Application No. 09/412,082
Amendment dated April 20, 2007

Amendments to the Drawings:

Application No. 09/412,082
Amendment dated April 20, 2007
ANNOTATED SHEET

FIG. 12

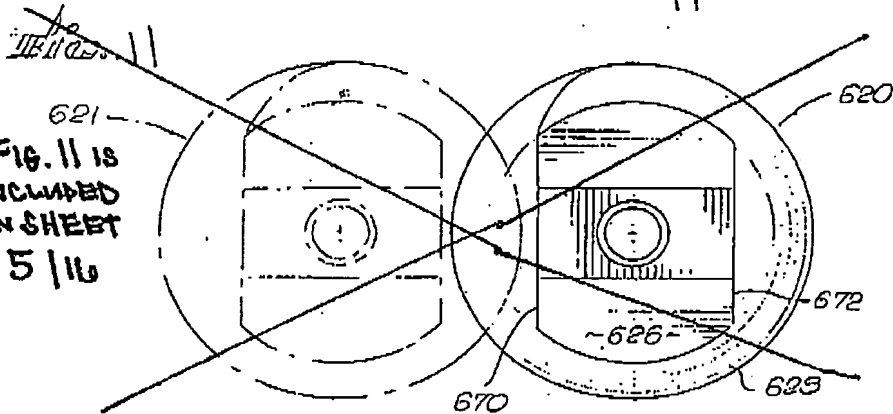
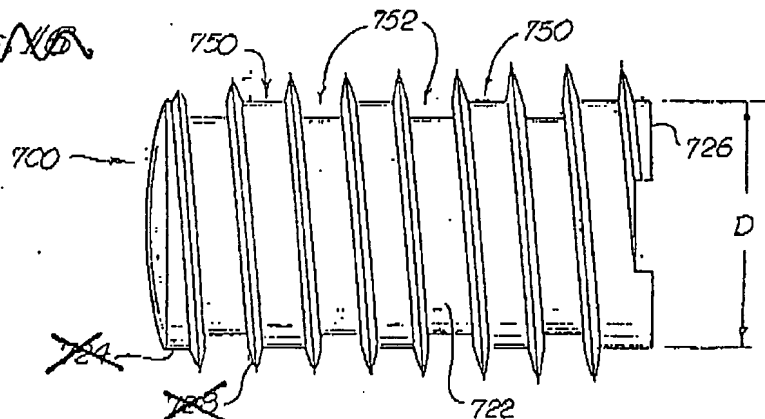
The attached sheets of drawings include a replacement sheet 7/16 incorporating changes to original Fig. 16, now identified as Fig. 12. Furthermore, the attached sheets of drawings include new sheets 8/16 – 16/16 containing Figs. 16-26. Figs. 16-26 correspond in substantial part to Figs. 1-4, 31, 33-37, and 40, respectively, of the U.S. Patent 6,080,155 incorporated by reference into the present application.

Furthermore, subsequent to the Notice of Allowance, Applicant noted that a complete original Fig. 16 was not included in a previous amendment to the drawings. As such, Applicant has amended the present application to include original Fig. 16, now identified Fig. 12.
